Urban Design Comments – March 2024	
Re: 21/503914/EIOUT Highsted Park, Land to the South and East of Sittingbourne (Highsted South)	
Background	Response by Milton Studio
The application seeks outline planning application for a large-scale mix use development with all matters reserved for future consideration. The proposed development is for up to 7,150 dwellings on land located to the south and east of Sittingbourne between the M2 and A2.	Commentary: Noted
The application site is predominantly undulating farmland with areas of woodland on the dip slope the North Downs and North Kent Plain. The southernmost part of the site lies within higher ground in the Kent National Landscape with the land broadly falling northwards towards the coastal plain. The comprises arable and pasture fields, commercial fruit growing areas and orchards subdivided by hedgerows, fences, roads, lanes, and farm tracks with pasture fields, with a scattered settlement pattern of farmsteads, hamlets, and isolated dwellings. Also within the site boundary is the Kent science park. The site extends so that it is near a range of settlements including Sittingbourne, Bapchild, Teynham, Rodmersham & Rodmersham Green, L

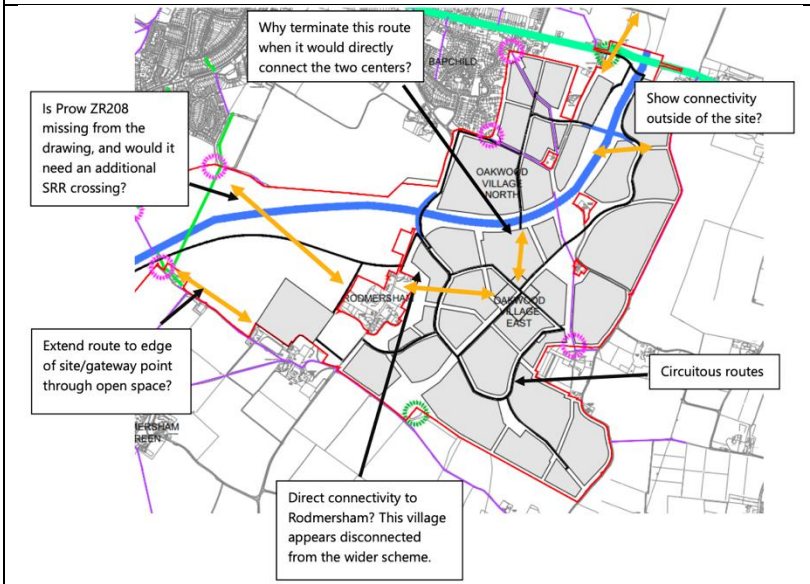
Other facilities, including proposed community gardens, primary school, and sports facilities are located on the southern periphery near Rodmersham Village. Whilst this may help soften the transition to the open countryside, these facilities are more removed from the new village. The new sports facilities, in particular, appear isolated from the new community.

Could these elements be integrated more effectively into the development and this area used to preserve agricultural/landscape setting to the village?

We also question why a potential direct link between the Oakwood centres has been terminated after the SRR crossing (image below).

Aim was to associate the sports provision with the new country park

Sports Hub Facilities are too large to easily integrate into development areas and better placed in a centralised location, accessible from external town and vilalges.

Plan amended.

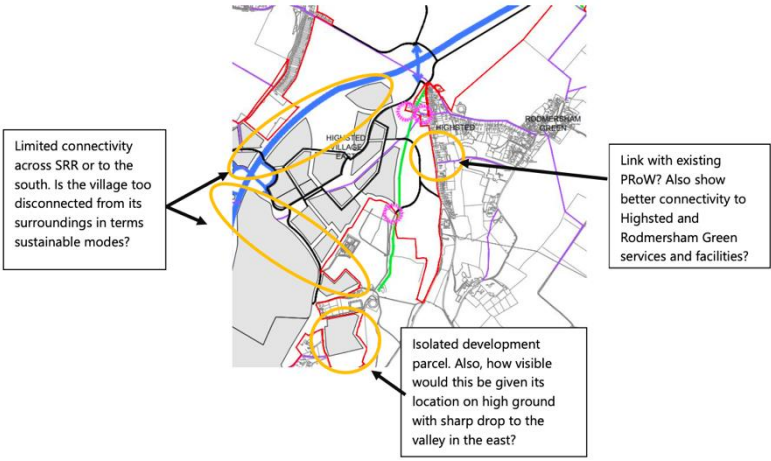
However, it is unclear how the development blocks have been informed by the undulating land levels as heights and densities appear broadly applied with little gradation. It is thus likely that elements of development parcels would be visually prominent in wider views.

Commentary noted

Density and height plans reviewed and revised
